OCG ref: AP2022/006

Response to Information Request: SDA Application for a MCU for a utility installation (water pipeline) and operational works (vegetation clearing) in the GSDA

GAWB refers to the State Development Area (SDA) application for a Material Change of Use (MCU) for a utility installation (water pipeline) and operational works (vegetation clearing) in the Gladstone State Development Area (GSDA). This application was formally lodged for the installation of the proposed Fitzroy to Gladstone Pipeline (FGP), with the Office of Coordinator-General (OCG) on 27 June 2023. We acknowledge receipt of the information request sent by OCG dated 23 August 2023 and have provided the following responses based on the gueries from the information request.

ANDREW SINN 26/09/23 DL 07 STANDARD DETAILS AIR VALVE ASSEMBLY 26/09/23

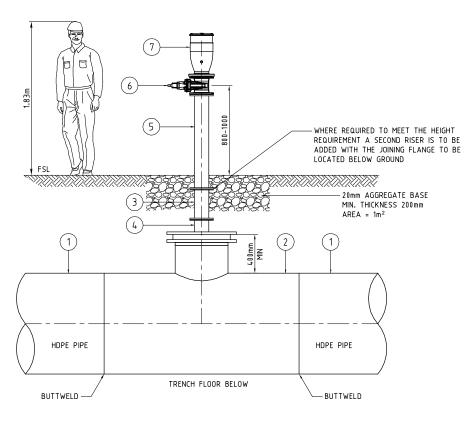
The proponent is requested to amend development plans and provide further detail regarding the air valve assembly (revised amount and design) with a view of reducing impacts along the transport corridor, with the aim of allowing motor vehicles along the infrastructure corridor (e.g., inspection vehicles and construction vehicles).

Scour valves and manholes are currently proposed to be located above ground, which may also impact the accessibility of the infrastructure corridor. To limit impacts on other proponents, locate scour valves and manholes at ground level wherever possible.

The proponent is requested to amend plans to locate scour valves at ground level to lessen development impacts within the infrastructure corridor. In areas where it is not feasible to locate the valves at ground level, identify and provide details of these locations and ensure that the distance between the scour valve and water pipeline is greater than 50 m.

The FGP now has a total of 226 AVs at a maximum spacing of 1,000 m and an average spacing of approximately 550 m. This total number has been reduced from the approximately 240 noted in the Planning Report for Material Change of Use for the Pipeline within the GSDA (Planning Report, GHD, 2023). Of these 226, 40 are within the GSDA, as shown on the issued for construction (IFC) design drawings broken down by landholder interest as follows:

The 40 AVs remains unchanged from the Planning Report (GHD, 2023) and was not able to be further reduced due to undulating nature of the topography and the intrinsic AV functionality requirements.

The AVs will be located on the pipeline alignment, with each to be protected with a post and rail arrangement, which also came out of the SiD / HAZOP workshop, refer to drawing 1151-DL00-W3P-CIV-DRG-10010 at Attachment A. Trafficability along the right of way (ROW) will not be compromised given a three-metre wide maintenance track is to be retained adjacent to and for the length of the pipeline alignment (excluding trenchless crossing locations) to enable inspection and maintenance access by 4WD vehicles (i.e., not a formed or gravelled road).
